## Validation opinion

### Request for revision of monitoring plan for project activity 0887 “Shenzhen Xiaping Landfill Gas Collection and Utilization Project” in China

### Pipe Modification Illustration

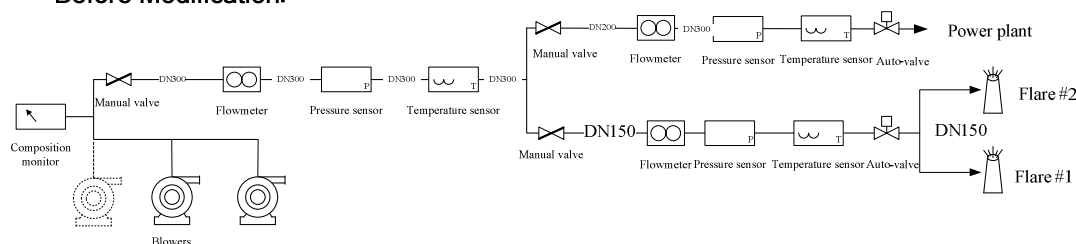
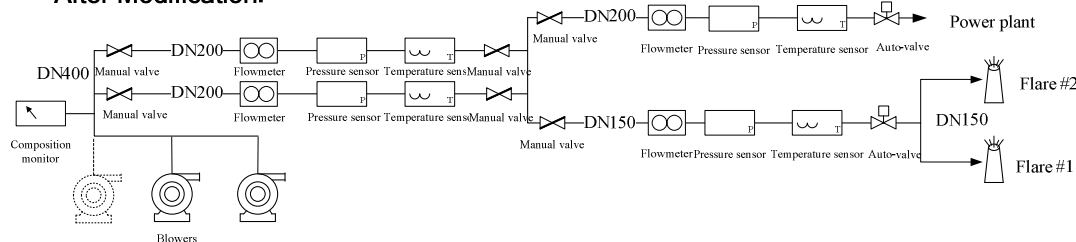
According to the monitoring plan in the approved project design document (version 7), the main flow rate is measured by one flow meter. Considering that the ultimate hourly flow rate might be high, a 300 mm-diameter main pipe with a flow meter ranging from 1270 m<sup>3</sup>/h to 10180m<sup>3</sup>/h has been installed. As per the investigation by project owner, the minimum flow rate of a 300 mm-diameter vortex flow meter always stays around 1000 m<sup>3</sup>/h (higher than the flow rate needs for operating of a generator at full capacity, i.e. 650m<sup>3</sup>/h). For instance, the minimum flow rate of a 300 mm-diameter *ROSEMENT* vortex flow meter is about 2597 m<sup>3</sup>/h, that of a YOKOGAWA produced vortex flow meter remains at about 1260 m<sup>3</sup>/h and that of an *E+H* vortex flow meter is about 2358 m<sup>3</sup>/h. After operating for a period of time, the project owner finds that the actual flow rate may be lower than 1270m<sup>3</sup>/h at the following two situations:

Consequently, this flow meter can not measure the actual minimum flow rate or a great error occurs to measurement. In order to guarantee that the error remains within the allowable limits, the project owner always shuts down the system when the actual flow rate is lower than the minimum of the flow meter and the effective operation time of this project thus reduces.

The main pipe is replaced by two 200 mm-diameter paralleling ones and two flow meters with a range of 530-8712 m<sup>3</sup>/h will be installed on each pipe for measurement (refer to the illustration below). In this condition, one flow meter will be used when the actual rate is lower than 8500 m<sup>3</sup>/h and both of the two will be used when the rate is higher than 8500 m<sup>3</sup>/h. A precise and wide measurement range will be available for this project. It should be noted that though the monitoring method has changed, the equipment calibration principles and QA/QC procedures will still comply with that set out in PDD (v7).
